Newcastle Inner City Bypass – Rankin Park to Jesmond

**Modification report: additional
construction compounds**

Submissions report

September 2021

Photo 1 – Peatties Road artificial wetland

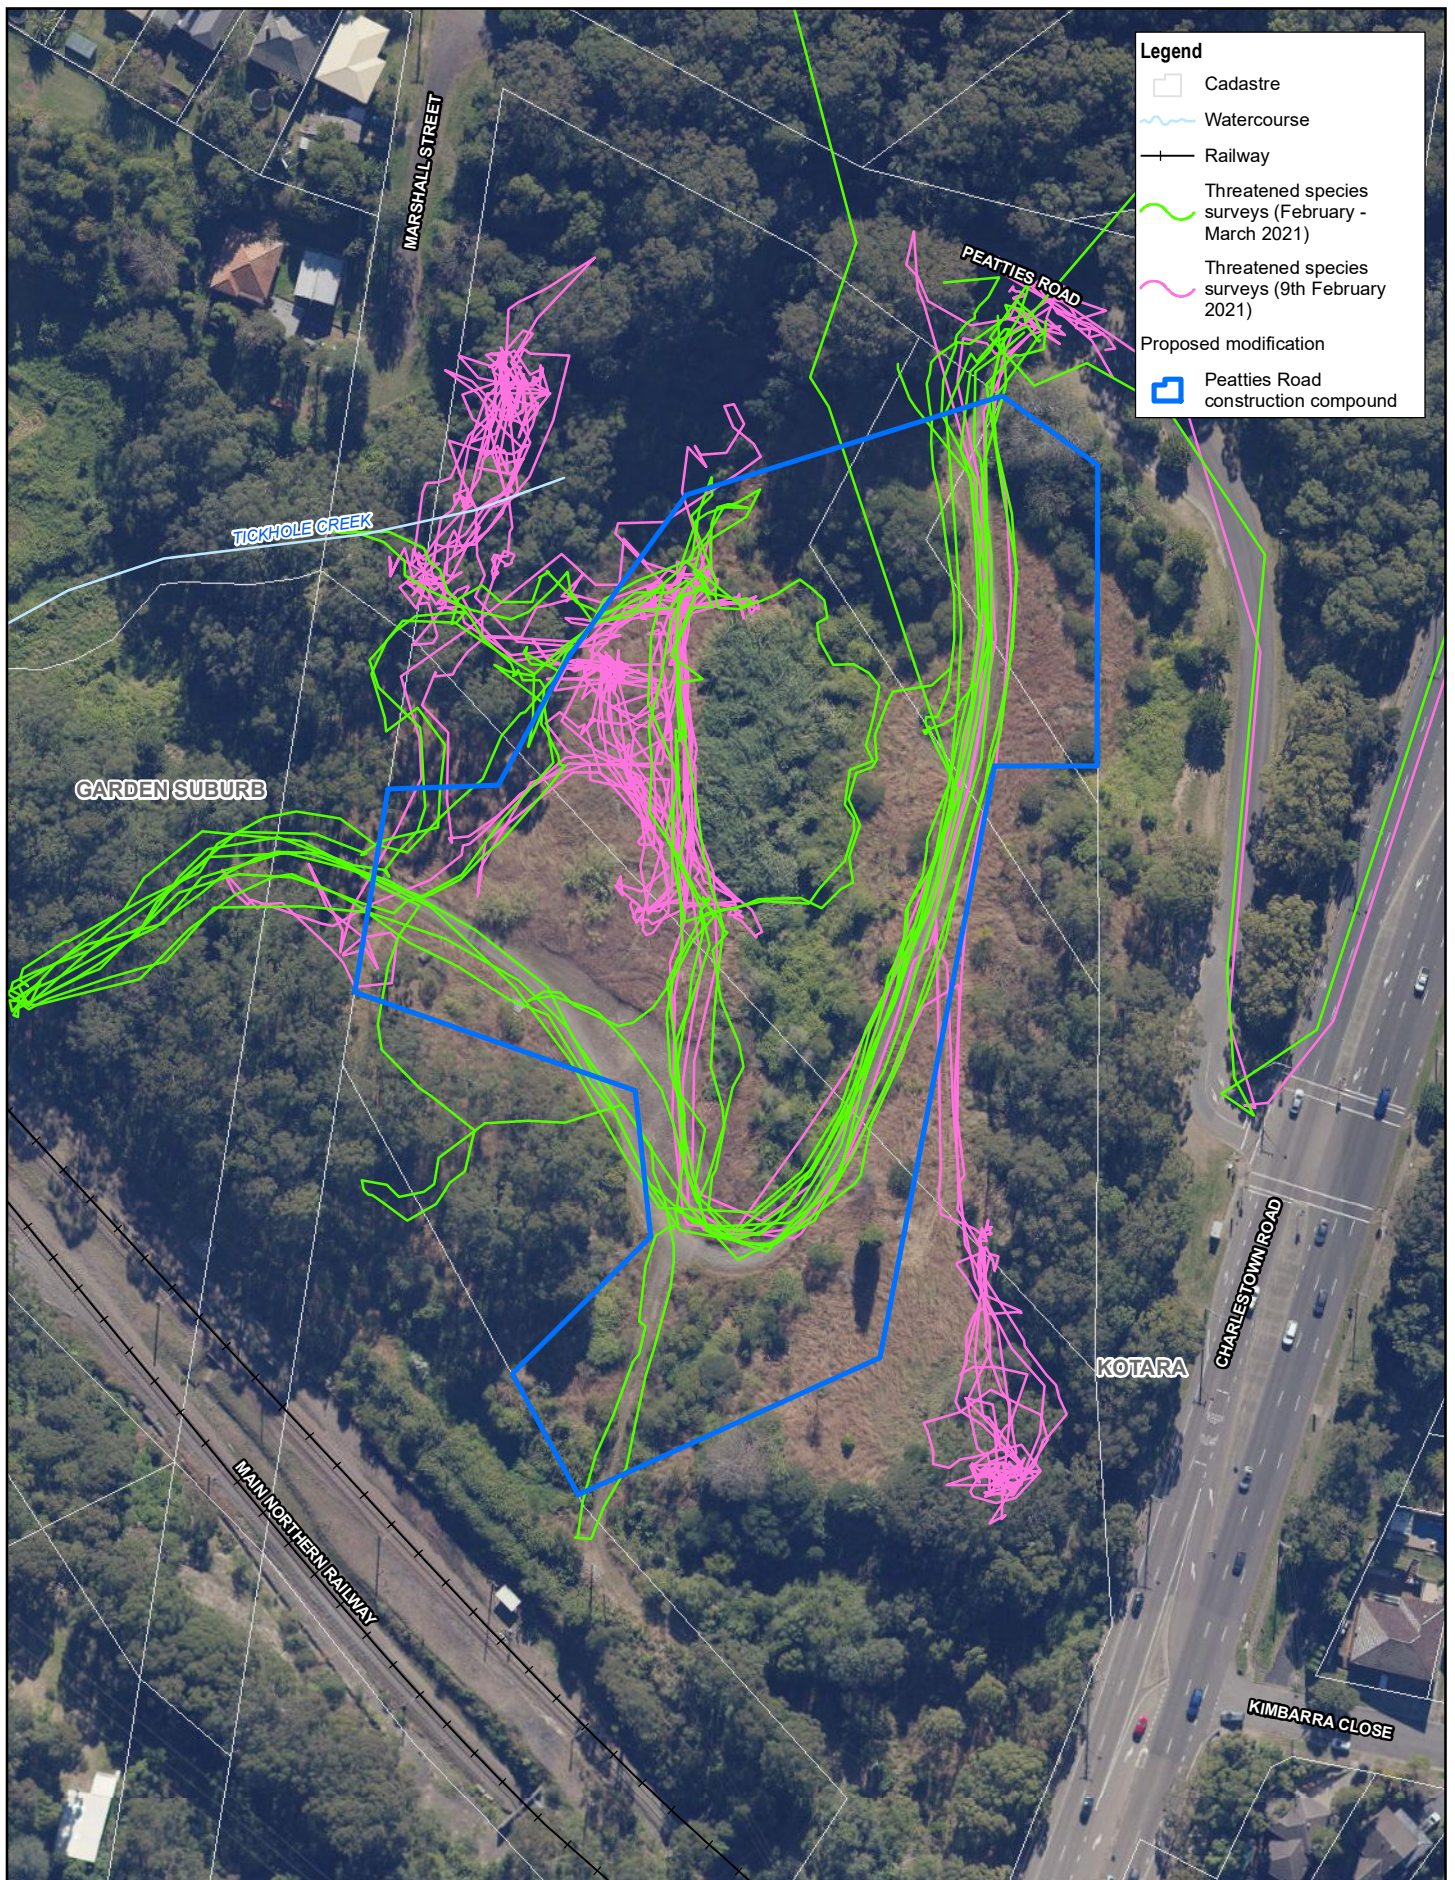
- City of Newcastle requested an arboricultural impact assessment and Tree Protection Plan for any street and park trees on City of Newcastle land within and adjacent to the construction compound and its accessway, and requested tree exclusion fencing based on Arboricultural impact assessment in accordance with Australian Standard AS4970-2009.

As identified in Section 5.2 of the BDAR two threatened flora surveys (Table 5-3) were completed in accordance with methods described in *Surveying threatened plants and their habitats NSW survey guide for the Biodiversity Assessment Method* (DPIE 2020). An initial random meander survey was completed on 9 February 2021 to collect vegetation plot data. A further site survey was carried out on 24 February 2021. This survey included opportunistic observations for threatened flora and fauna. These surveys did not detect any *Maundia triglochoides* and determined that site is unlikely to provide suitable habitat for this species. Figure 5.1 in the BDAR has been updated as Figure 4.1 below.

Survey efforts were restricted to the outer edge of the artificial wetland due to the extremely dense vegetation growth within the wetland which made the area impenetrable as shown in Photo 1 (also provided as photograph 1 in the BDAR) and Photo 2. *Maundia triglochoides* is known to occur in permanent swamps, lagoons, dams, channels, creeks or shallow freshwater 30 to 60 centimetres on heavy clay, low nutrient soils (DPIE 2021). The wetland area within the Peatties Road site does not contain any freestanding water, contains dense thickets of vegetation including a high abundance of exotic species and occurs on a loam substrate rather than heavy clays with which this species is typically associated.

Native vegetation removal is generally not proposed within the modification areas other than 0.2 hectares of low condition artificially created wetland at Peatties Road. A minimum buffer distance of three metres between the compound site boundary and adjacent areas of native vegetation has been provided at Peatties Road. Additionally, environmental management measures BD07 requires tree exclusion zones be identified and demarcated in accordance with Transport's Biodiversity Guidelines: Protecting and managing biodiversity on RTA projects (RTA 2011a). Guide two, which has been prepared to meet the Australian Standard AS4970-2009, identifies the management requirements for determining and establishing tree exclusion zones. One example is using the area directly under the tree branches, known as the drip line, as a practical way of determining the tree exclusion zone. Tree exclusion zones would be established in accordance with Australian Standard AS4970-2009 through the implementation of Transport's Biodiversity Guidelines.

Figure 5-1

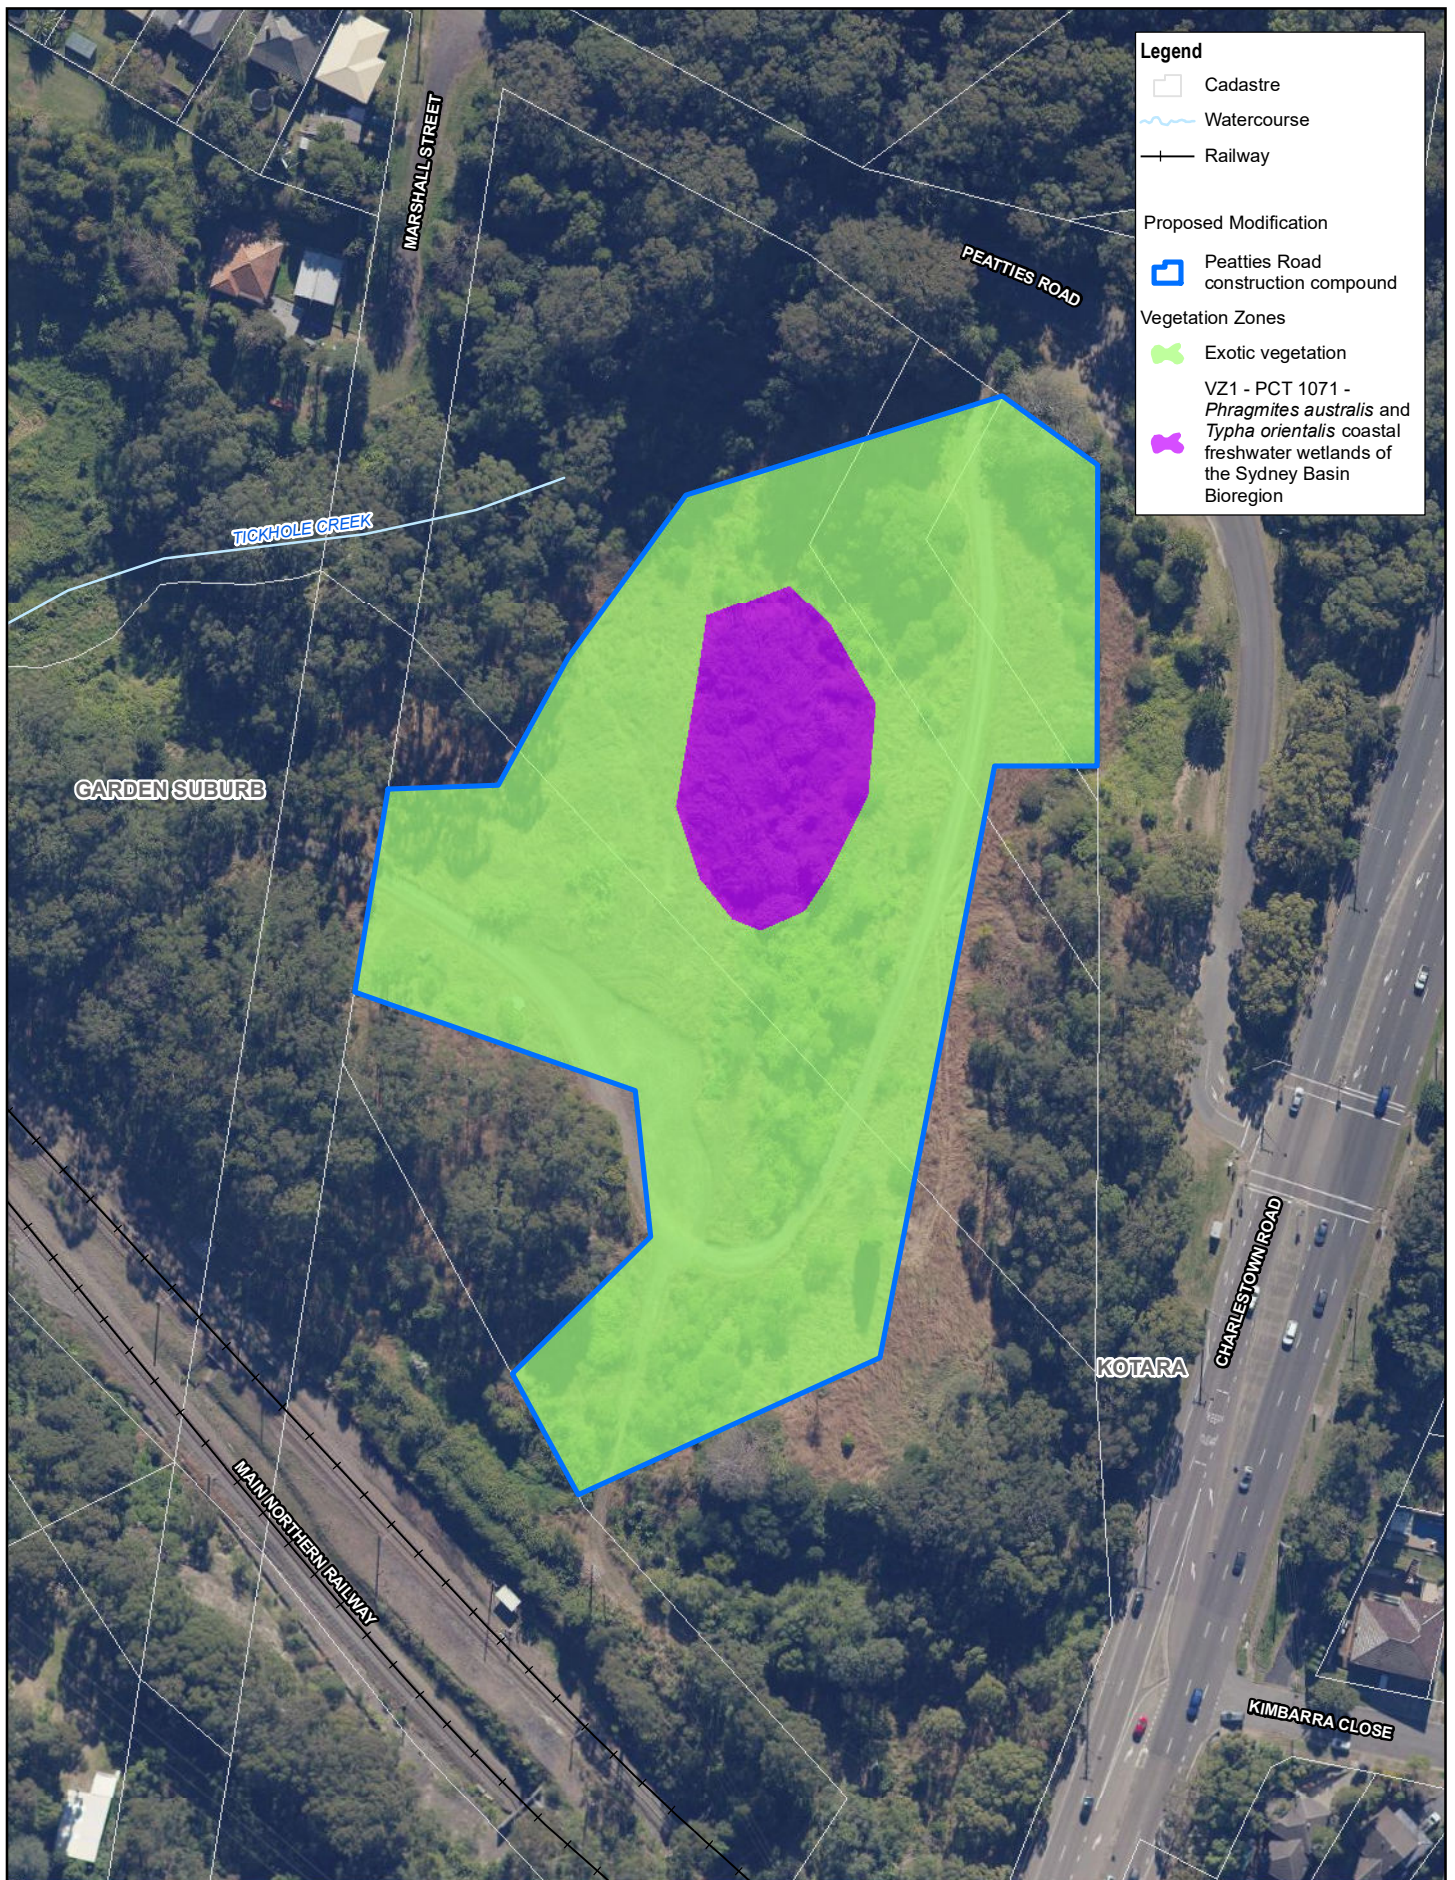
- Requested details on the trees to be removed
- Noted that the Plant Community Type (PCT) at Peatties Road is incorrect
- Commented that the modification report does not address weed management

The area of each compound site proposed to be used are shown in figures 4.1a to 4.1d of the BDAR. The area to be used within Peatties Road compound site is also included in Figure 5.1 of this report. The BDAR is provided as Appendix D to the modification report. Tree removal would be limited to within those areas, with tree protection measures provided in accordance with environmental mitigation measures detail in Appendix H of the modification report.

A site survey was carried out by ecologists in February 2021. This site survey included vegetation mapping. To determine the appropriate Plant Community Types (PCTs) for the site the following data was collected in the field and then compared against PCTs outlined in the BioNet Vegetation Classification Database (OEH 2020):

Details of the survey methodology and PCT description are provided in Section 4 for the BDAR. The full flora species list used to classify the PCT is provided in Annexure A of the BDAR.

Figure 6.1
 Peatties Road - heritage sites

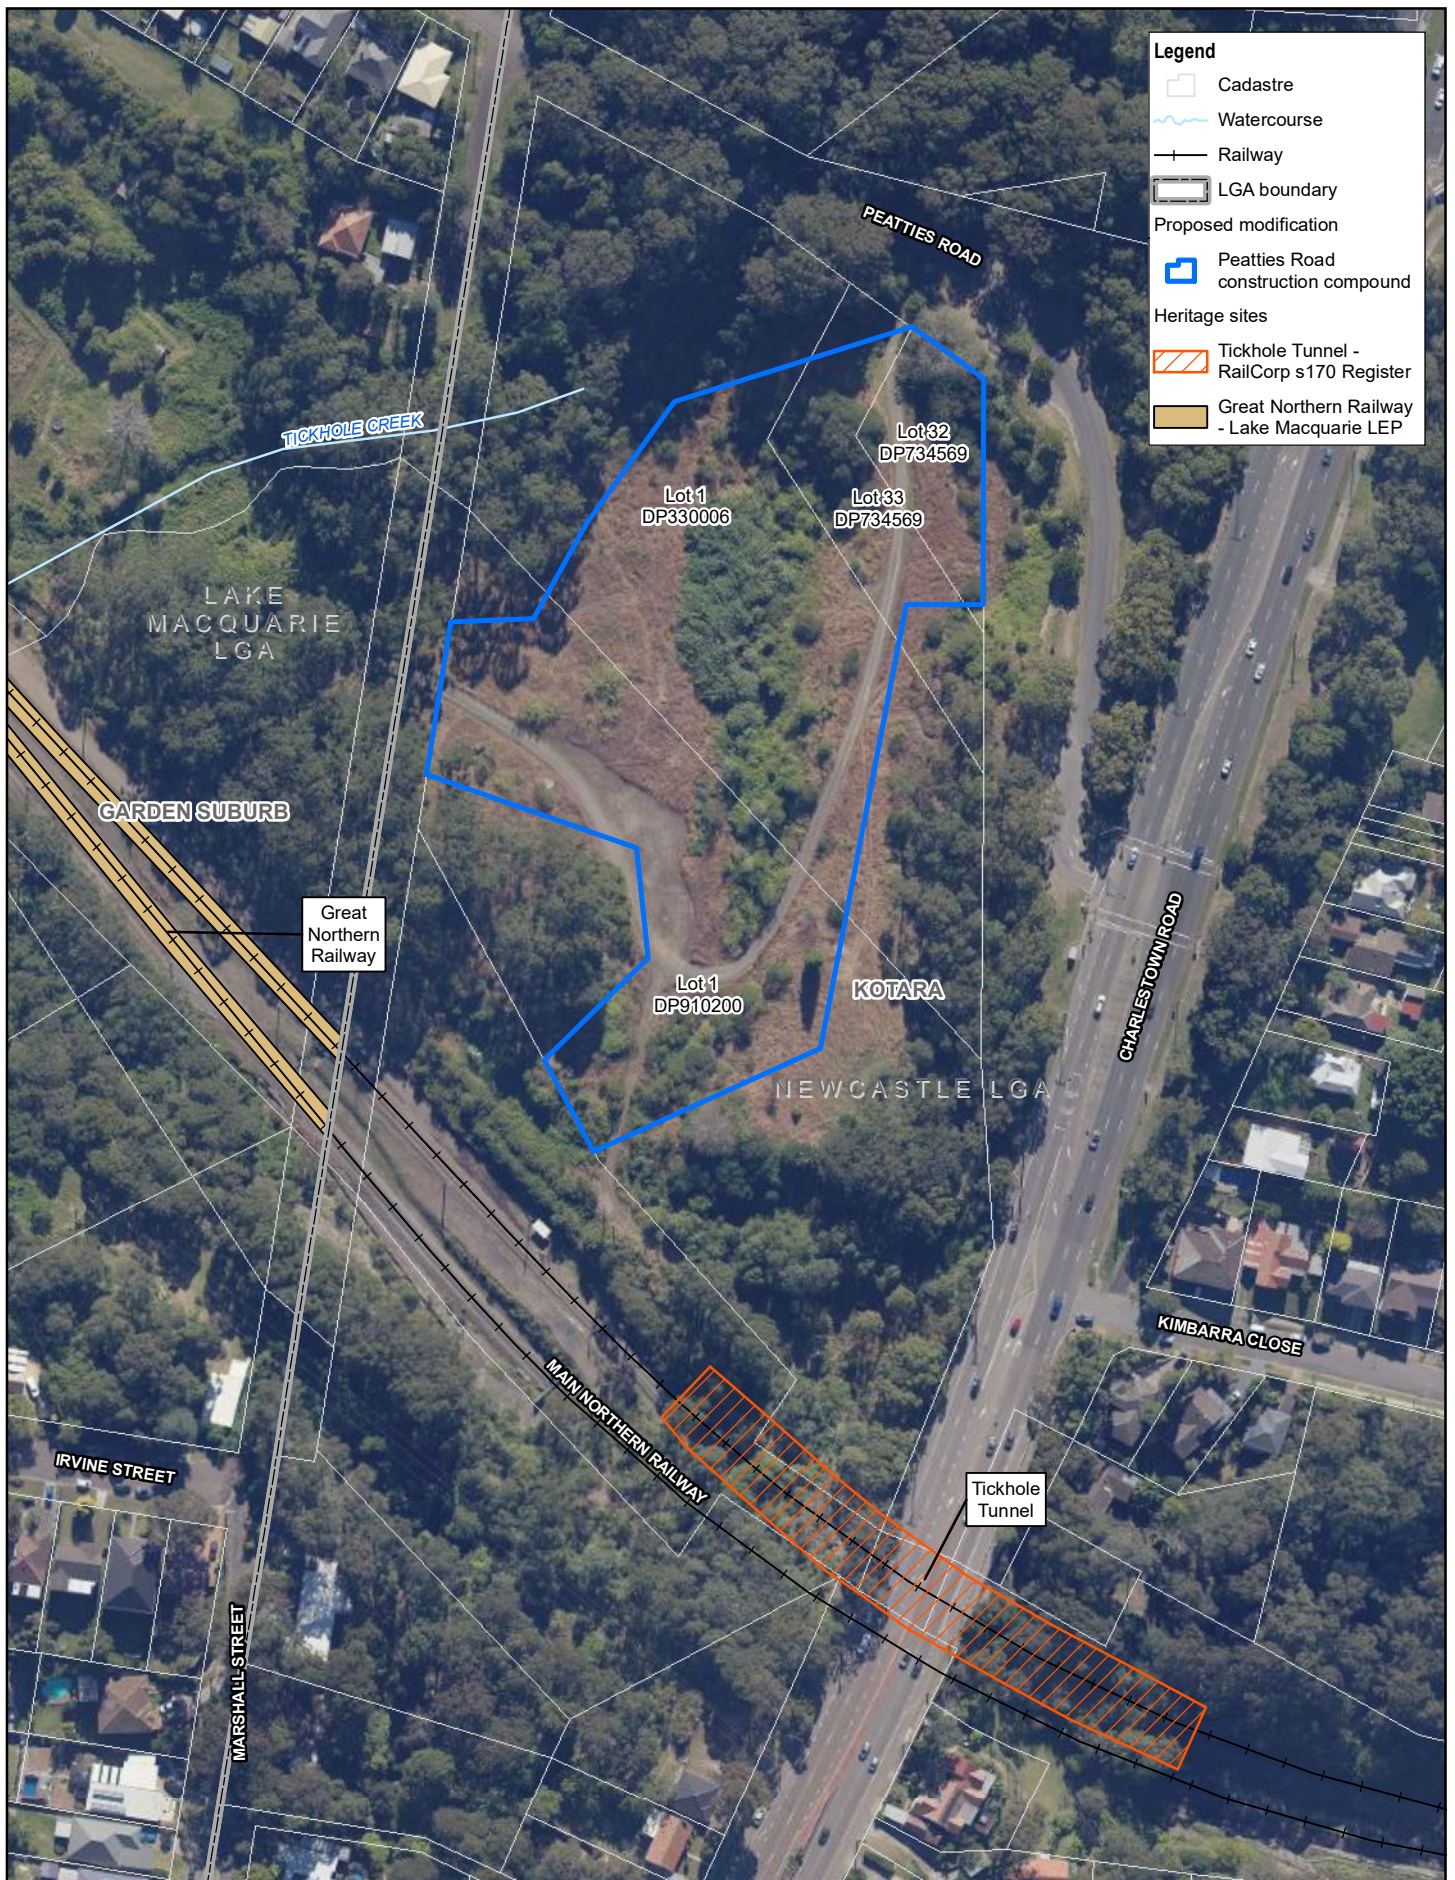
In response to submissions, additional studies were carried out for Section 170 listed Tickhole Tunnel and for potential traffic and transportation impacts at Peatties Road.

A search of the NSW State Heritage Inventory that includes Section 170 registers was completed on 10 August 2021. No listed non-Aboriginal heritage items were identified as occurring within the modification area. The closest Section 170 listed non-Aboriginal heritage item is Tickhole Tunnel, which is a brick lined, 153 metre long double track railway tunnel constructed in 1887 on the northern-leg of the Main Northern Rail Line which passes under Charlestown Road. Tickhole Tunnel is located about 65 metres to the south of the Peatties Road compound, as shown in Figure 6.1.

- Tickhole Tunnel which has historical significance at a local level, is located on the northern-leg of the Main Northern Rail Line and passes under Charlestown Road. At the western portal Tickhole Tunnel is about 65 metres from the Peatties Road compound.

While Tickhole Tunnel is outside the 35 metre buffer distance for heritage structures at risk from vibratory rolling, due to the nature of this structure and importance for operation of the Main Northern Rail Line an additional mitigation measure has been recommended **Error! Reference source not found.**
